Sink Accessories 3-1/2" Drain LK35, LK35B and LK35L Models

Shop Drawing Submittal Review

Project Name: Webster University-**ISB**

Copies	No.	Description
1 PDF	224216P02	(Submittal No.'s)
		(Cannon #22 4216.16-001) - (Paric #15051-) - (WES #607)
		➤ Commercial Sinks
		• Clinical Service Sink CSS-1
		• Scrub Sink SS-1
		• Sink SK-1
		• Garbage Disposer GD-1
		• Sink SK-2
		• Sink SK-3
		• Mop Sink MS-1
		• Kitchen Sinks KS-1, KS-2, KS-3

SK-3

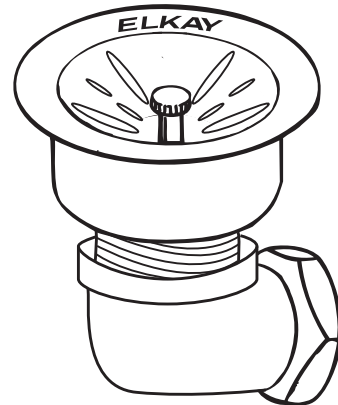
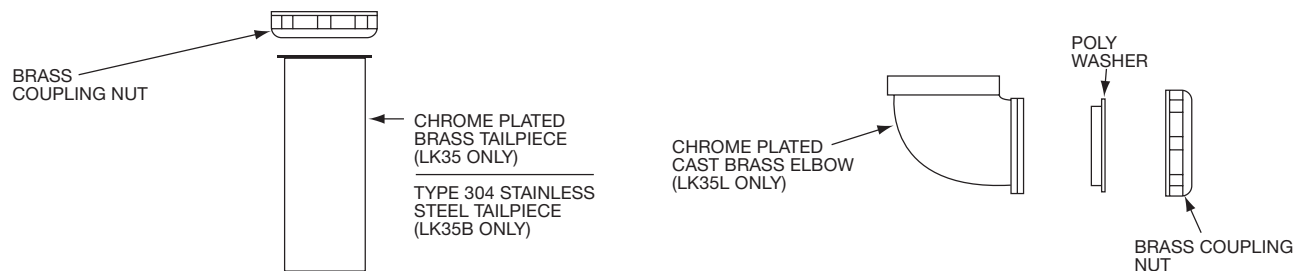
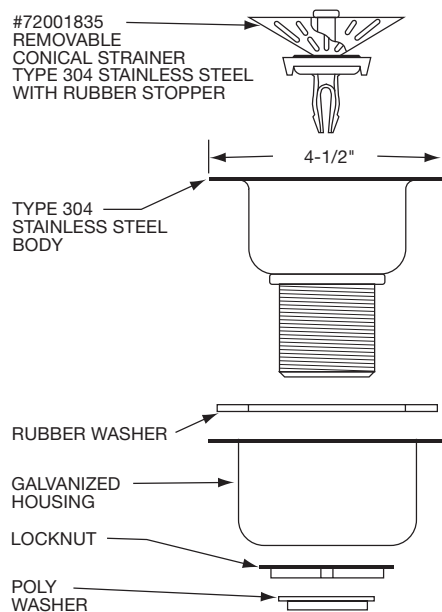
1. Sink is integral with the counter-top. Coordinate with the architectural drawings.
2. Provide under counter waste and supply protective piping covers as required.
Verify requirements with the architectural drawings.
3. Escutcheons are specified to be cast brass. Refer to specification section 220518.
